STAFF RECOMMENDATION

1005 Acklen Avenue
November 20, 2019

Application: New Construction—Addition and Outbuilding/DADU
District: Waverly-Belmont Neighborhood Conservation Zoning Overlay
Council District: 07
Base Zoning: R8
Map and Parcel Number: 10509020200
Applicant: William Smallman
Project Lead: Melissa Baldock, melissa.baldock@yahoo.com

1005 ACKLEN AVENUE
 SITE PLAN • SCALE: 1/16"=1'

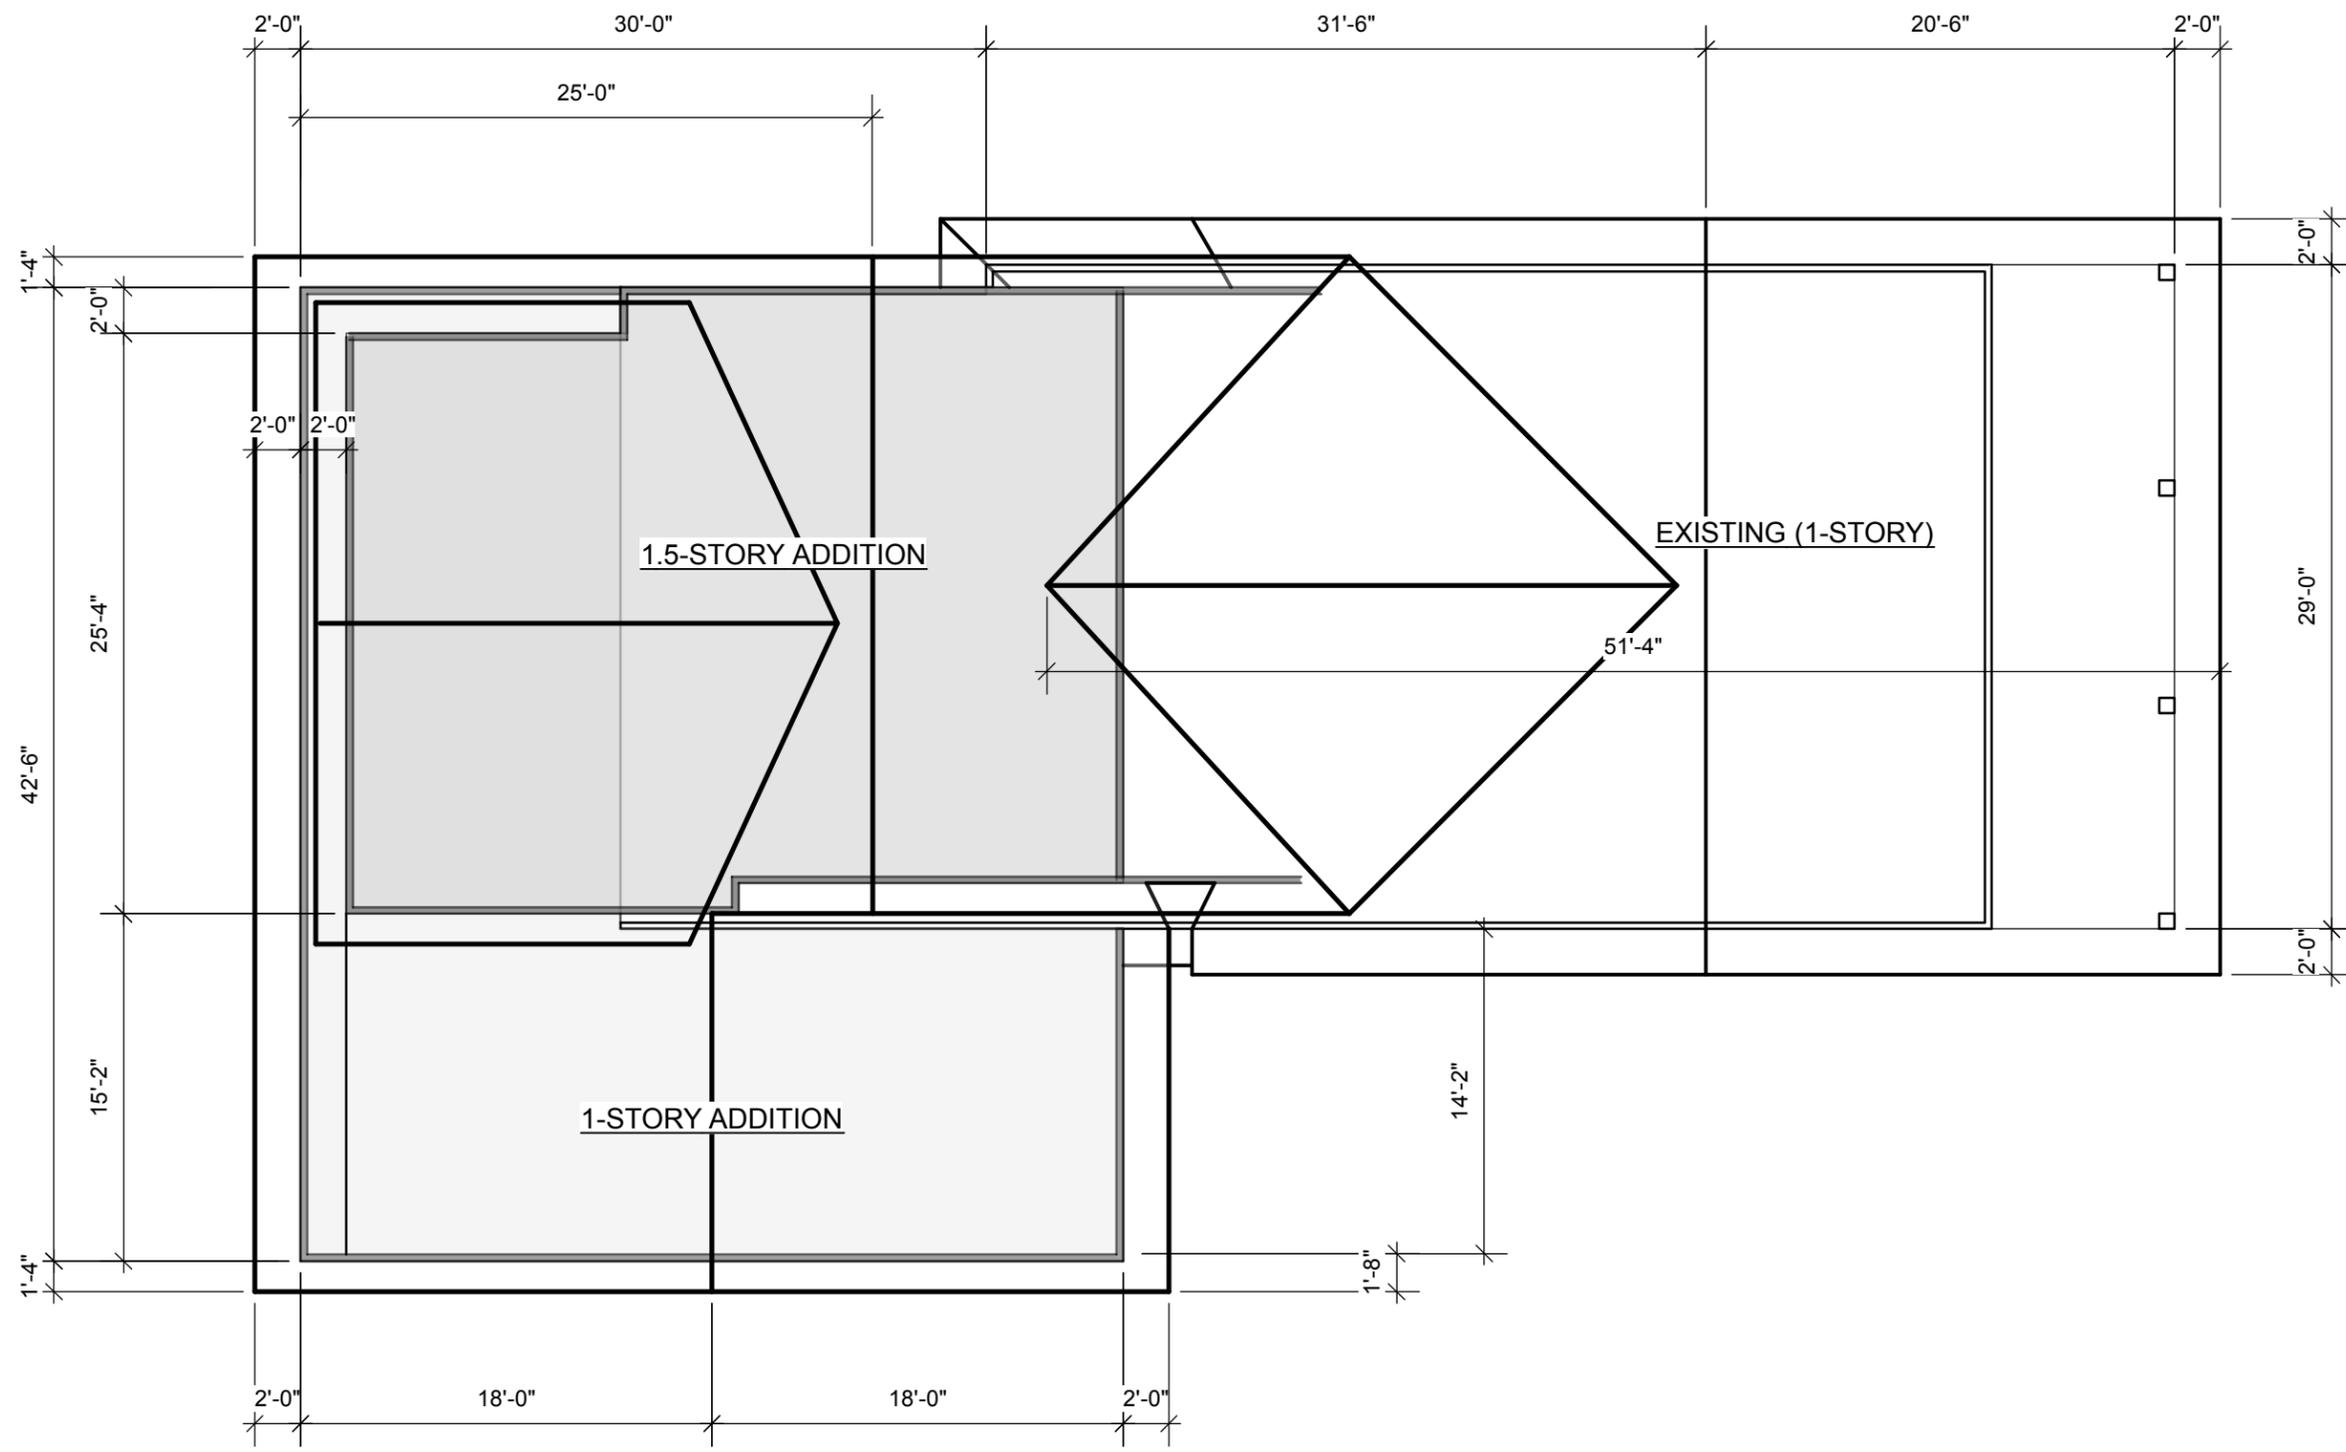
Setback & Rhythm of Spacing: The proposed addition meets all base zoning setbacks. It will be over nineteen feet (19') from the right side property line, and ten feet (10') from the left side property line. It will be over forty feet (40') from the rear property line. The fact that the addition is wider than the historic house will not affect the rhythm of spacing of historic houses along Acklen Avenue, since the wider portion of the addition is over seventy feet (70') back from the front property line.

The outbuilding is located at the rear of the lot and will be accessed via the alley. As proposed the outbuilding meets all base zoning setbacks but is located less than twenty feet (20') from the rear of the proposed addition. Staff finds that the distance of seventeen feet, one inch (17'1'') between the back of the house and the DADU to be appropriate in this instance because the lot is shallow at just one hundred and fifty-three feet (153').

1005 ACKLEN AVENUE
 ELEVATIONS • SCALE: 1/8"=1'

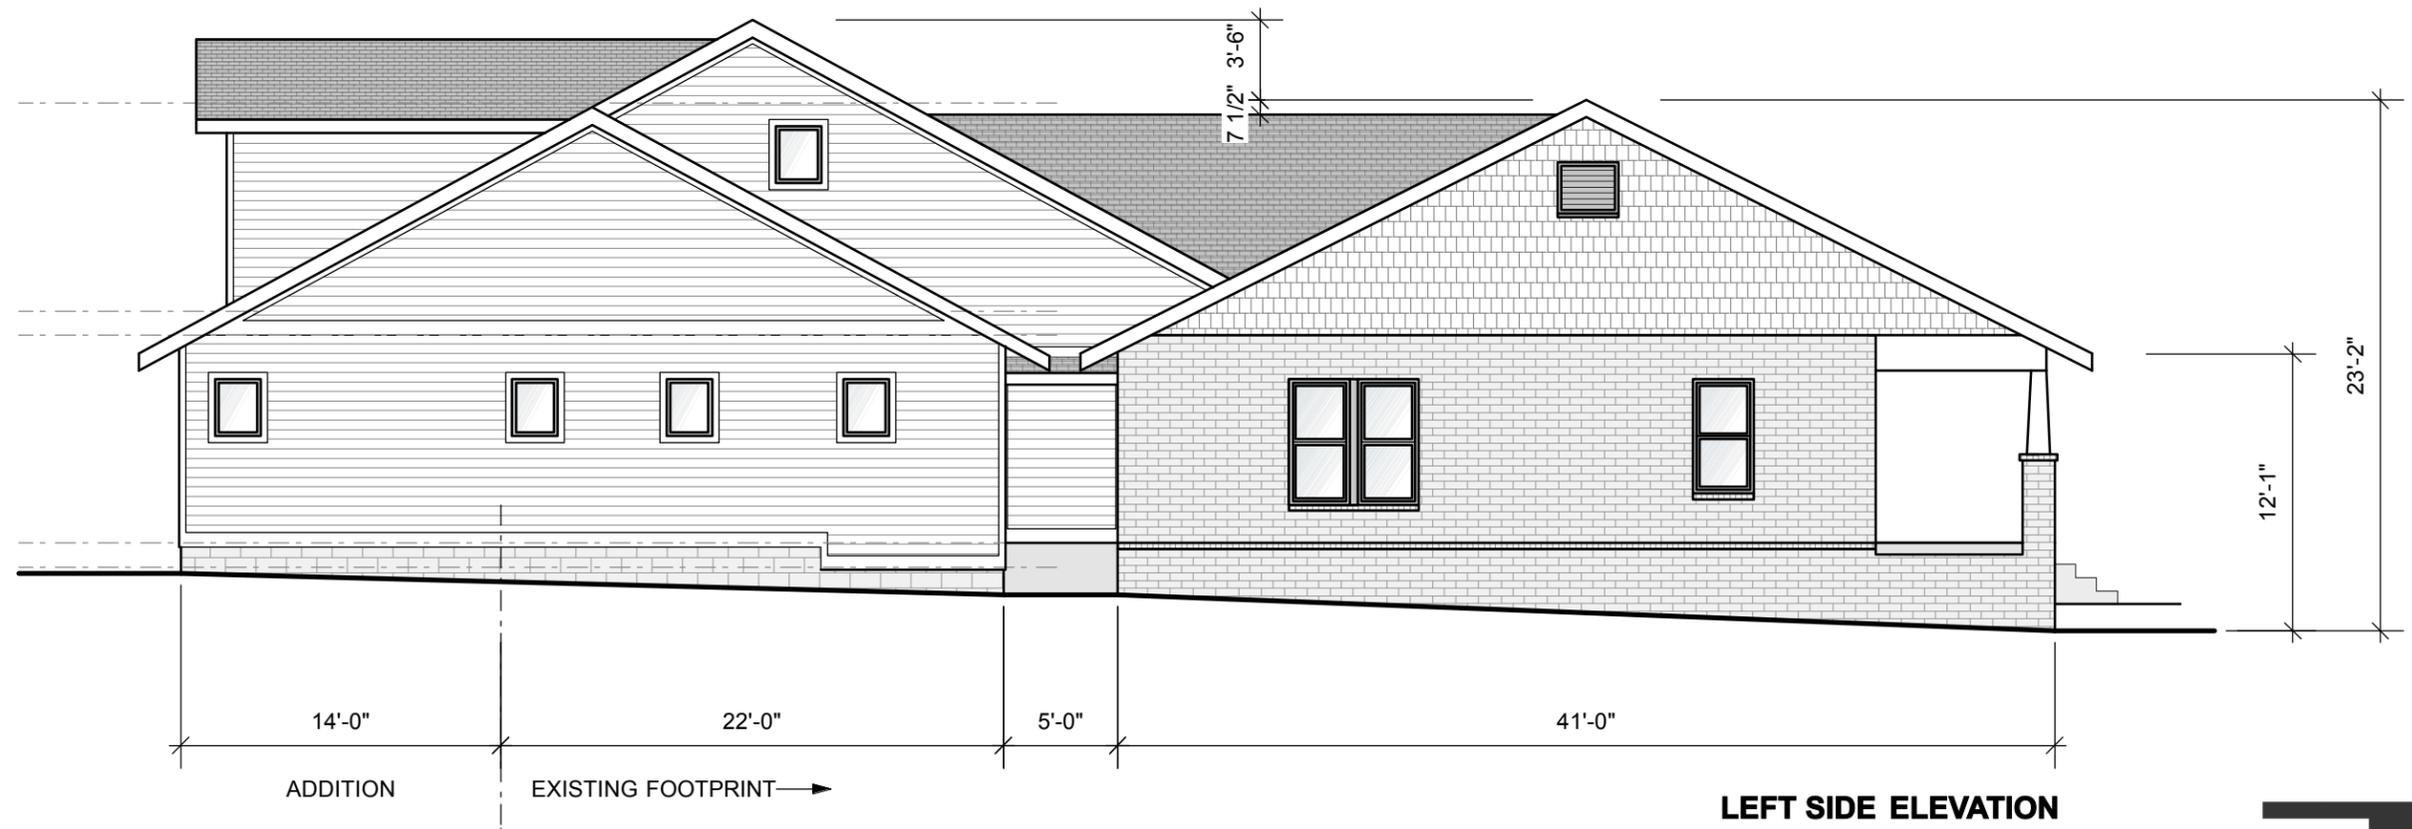
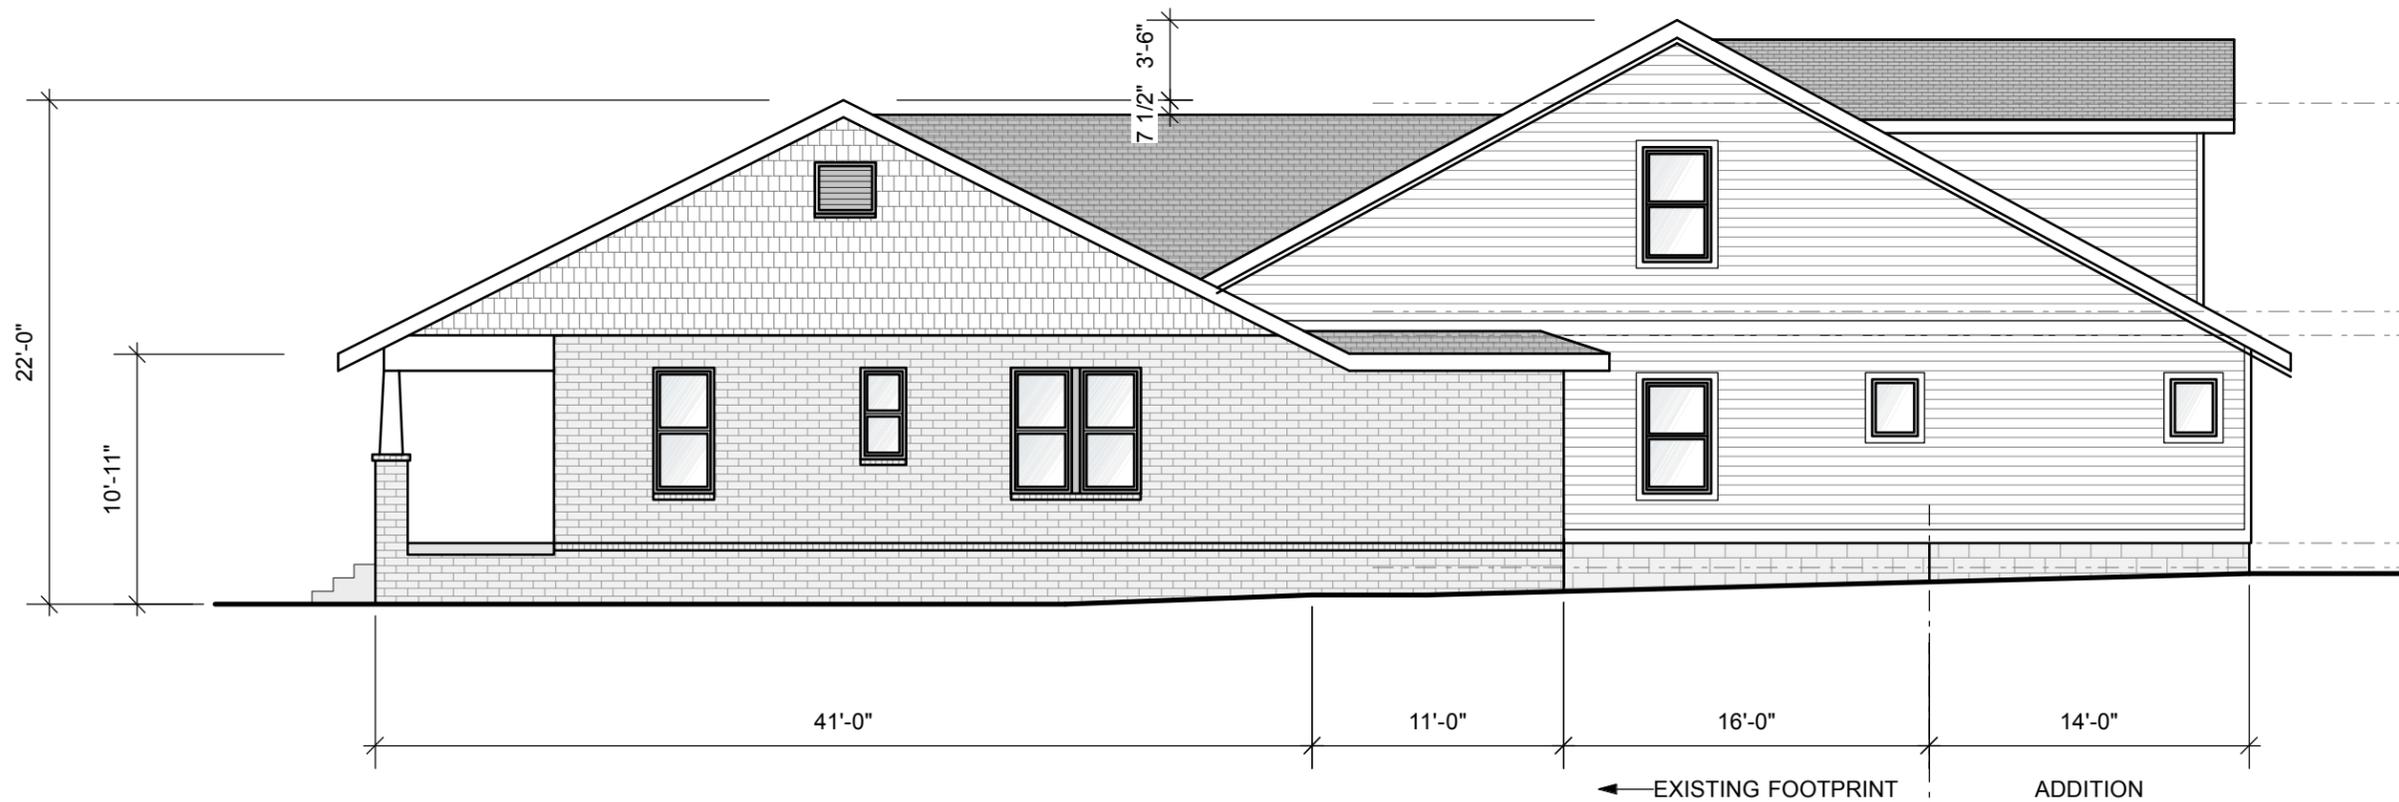
Height & Scale: The applicant plans to construct on top of the existing addition. The existing addition is not inset on the left side and is only inset one foot (1') on the right side. Because the existing addition will be retained and more addition constructed on top of it, the addition will not be inset as is typically required.

The proposed addition is both taller and wider than the historic house. The addition will be up to three feet, six inches (3'6") taller than the historic house. The design guidelines states that additions can be up to four feet (4') taller than the historic house when a taller addition is the "only option." The Commission has routinely approved additions that are two feet (2') taller than the historic house, as a ridge raise is typically allowed to increase the height of the historic house by two feet (2'). However, more recently, the Commission has been concerned about additions being more than two feet (2') taller,

unless the taller addition is indeed the only option. In this case, staff finds that because of the significant slope of the lot, an addition that is three feet, six inches (3'6") taller is appropriate. The steep slope will require the applicant to do some substantial digging in the site and to construct a retaining wall. A taller addition will help to have more usable second story space, allowing the applicant to keep the depth of the addition modest. The addition will add just fourteen feet (14') of depth to the existing structure.

The wider portion of the addition occurs on the left side. The addition becomes wider than the historic house at a point approximately four feet, six inches (4'6") beyond what would have been the historic back wall of the house. The wider portion of the addition is fourteen feet (14'6") wider than the historic house, which meets the design guidelines. It is also approximately six inches (6") lower in height than the historic house and has a side gable form.

The design guidelines state that additions "should not be higher and extend wider," as is proposed in this application. Staff, however, finds the taller and wider addition to be appropriate in this instance because of the severe slope of the lot. By allowing the addition to go both wider and three feet, six inches (3'6") taller than the historic house, the applicant is able to have a smaller footprint for the addition. In addition, the lot is wide at seventy-two feet (72'), but is relatively shallow at about one hundred and fifty-three feet (153'). A wider addition, and an addition that is taller, allows the footprint of the addition to be shallower, which is particularly important when the slope of the lot is taken into consideration. Overall, the applicant is adding approximately nine hundred square feet (900 sq. ft.) of footprint to the existing house, which has a current footprint of about one thousand, nine hundred, and fifty square feet (1,950 sq. ft.). Staff finds this to be appropriate.

Roof form: The addition has a combination of gable roof forms that have a 6/12 slope to match the main gable slope on the historic house. The addition does include a rear gabled dormer that is inset appropriately. Staff finds that the proposed roof forms are compatible with the historic house's roof form.

Staff finds that the proposed addition's height and scale meet Sections III.A., III.B., and IV. of the design guidelines.

Staff finds that the proposed roof forms meet Sections III.E. and IV. of the design guidelines.

1005 ACKLEN AVENUE
DADU ELEVATIONS • SCALE: 1/8"=1'

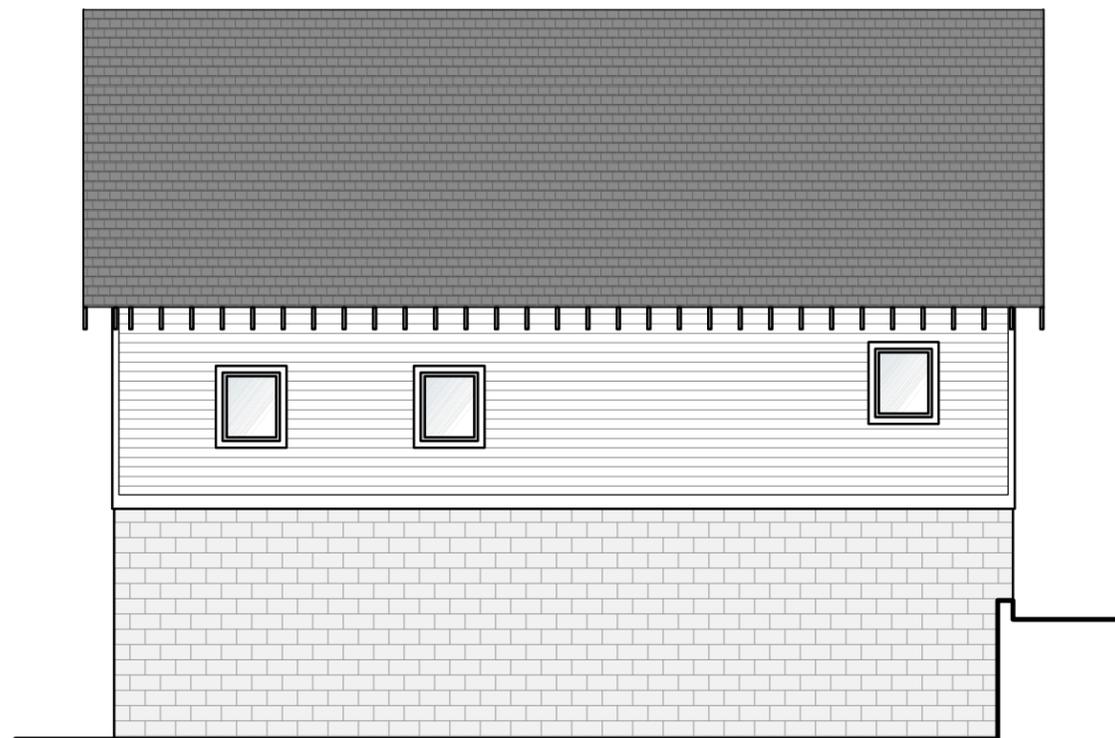
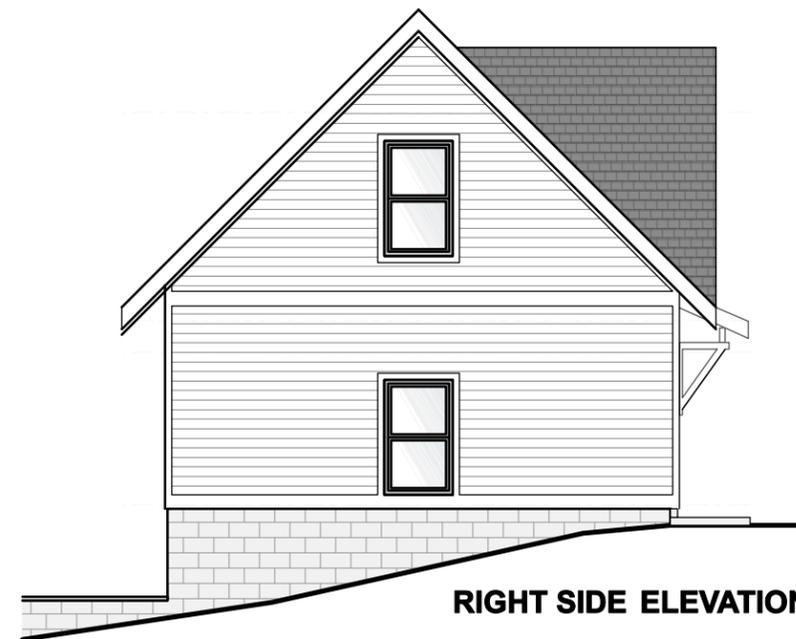
* The outbuilding/DADU will have an eave height of approximately nine feet, six inches (9'6") and a ridge height of twenty-two feet, six inches (22'6") at the alley. However, because of a substantial drop in grade it will gain a partial basement level on the façade facing the house. Staff does not consider this to be a two-story outbuilding because the additional level is below the primary grade at the alley. MHZC approved a similarly-scaled DADU two houses to the west at 1009 Acklen in 2016, where the slope of the lot is very similar to the slope of this lot.

The roof form does not include any dormers. Staff finds that the outbuilding/DADU meets Section III.H.3 of the design guidelines for roof shape and Section 17.16.030.G.8 for design standards of the DADU Ordinance.

Staff finds that the proposed DADU meets Section III.H.1.c of the design guidelines and Section 17.16.030.G.7 of the DADU Ordinance for height and scale.
